**ADDENDUM ENVIRONMENTAL IMPACT ASSESSMENT REPORT
VOLUME 1: ADDENDUM NON-TECHINCAL SUMMARY**

RIVERINE COMMUNITY PARK

LIFFORD-STRABANE

APRIL 2022

Figure 1-1: Updated Red Line Boundary

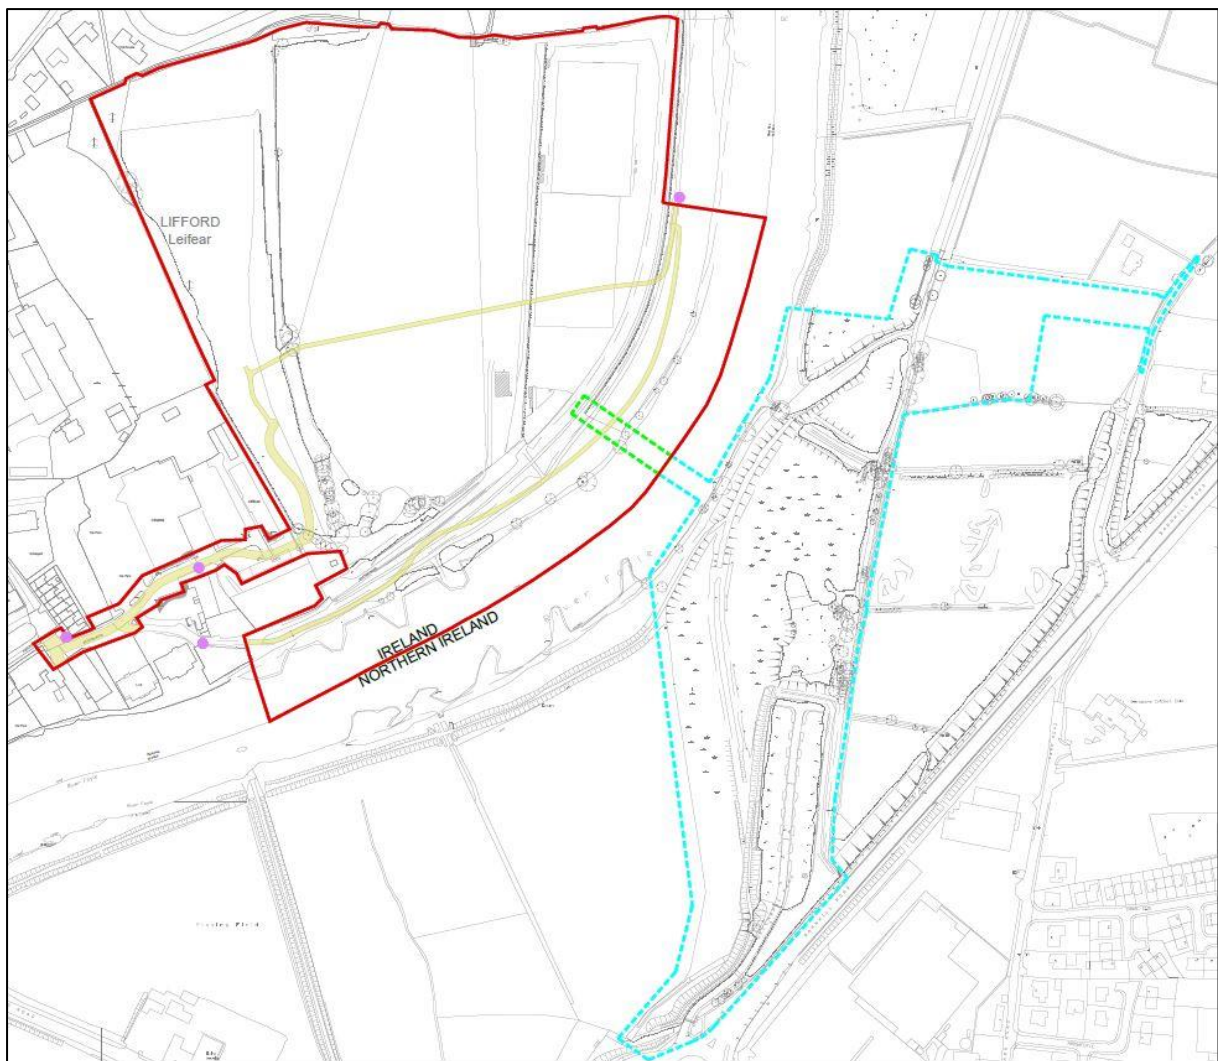
The Addendum EIA involves an update to the red line boundary of the Project in order to accommodate the largest possible scale temporary bridge construction platform. Planning drawings with the updated red line boundary have been submitted however the maps shown with the Addendum EIA Main Text (Volume 2) and the Addendum Appendices (Volume 3) have not been updated. The revised red boundary is shown in Figure 1-1 below for information.

Please refer back to this boundary when a site map is shown within the Addendum EIA (including appendices). Both the original and Addendum EIA have assessed not just the site itself but also the surrounding environs and therefore this amendment to the red line boundary has no impact on the assessments completed to date.
